APPLICATION FOR SOIL INVESTIGATION

APPENDIX II
SITE EVALUATION

SITE INVESTIGATION REPORT
INDIVIDUAL SEPTIC TANK SYSTEM
WITH SUBSURFACE,
SOIL ABSORPTION,
EFFLUENT DISCHARGE

LOCATION OF LOT PUckett Road, Lot 3

* See Diagram on Back (Include: Soil areas, property lines, roads, streams, gullies wet areas, fill areas, wells, water bodies, slope patterns, etc

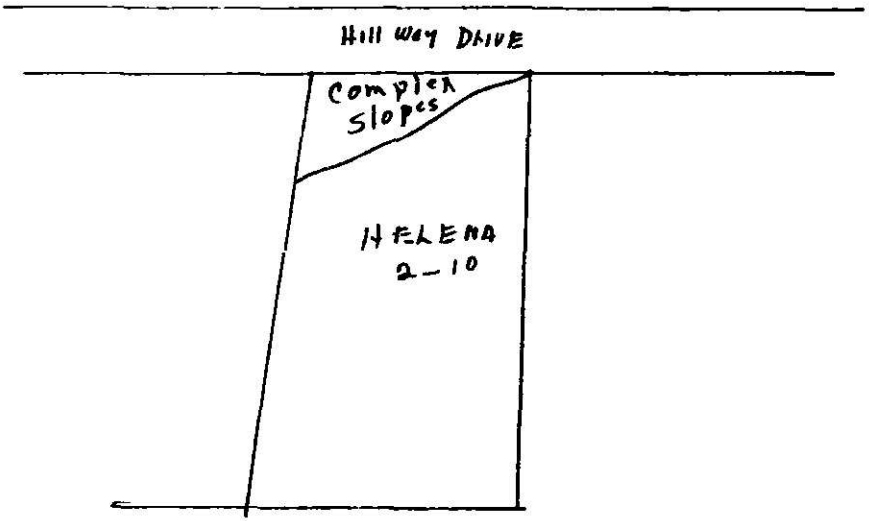
FACTORS	AREA 1	AREA 2	AREA 3	AREA 4
1. SLOPE (%)	S (PS) U — 2-10	S PS (U) — Complex	S PS U	S PS U +
2. SOIL TEXTURE (12-36 in.) (Sandy, loamy, clayey, Note 2:1 Clay)	S PS (U) — Clay 2-1	S PS (U) — 2-1	S PS U	S PS U
3. SOIL STRUCTURE (12.36 in.) (Clayey Soils)	S PS (U) — Massive	S PS (U) — Saprolite	S PS U	S PS U
4. SOIL DEPTH (In.)	S (PS) U — <48	S PS (U) — <48	S PS U	S PS U
5. RESTRICTIVE HORIZONS (In.) (Impervious Strata, Rock)	S PS (U) — Clays	S PS (U) — Clays	S PS U	S PS U
6. SOIL DRAINAGE/GROUNDWATER (External & internal)	S PS (U) — SLOW	S PS (U) — SLOW	S PS U	S PS U
7. SOIL PERMEABILITY (Percolation Rate)	S PS (U) — SLOW	S PS (U) — SLOW	S PS U	S PS U
8. OTHER (Specify)	S PS U	S PS U	S PS U	S PS U
9. SITE CLASSIFICATION	Unsuitable	UNSUITABLE		
SOIL SERIES	HELENA	Complex Slopes

Hill way DRIVE
complex slopes
HELENA
2-10

Soil Structure Massive

Soil Permeability Unsuitable

Sites classified as Unsuitable are not acceptable for soil absorption of sewage effluent However, if engineering, geologic, soil, and environmental studies indicate that a suitable septic tank system or a suitable alternate system can be expected to function satisfactorily, such sites may be re-classified as Provisionally Suitable. (Section 10 of the North Carolina Administrative Code 10 A,.1910)

If you desire to file for permission to install an "alternate or modified" system, you should present this office with your proposals in the form of plans and specifications. These would be reviewed and if it is found that the system may reasonably be expected to function satisfactorily, approval may be given on the execution by you of a "Septic Tank Agreement Form" available in this office.
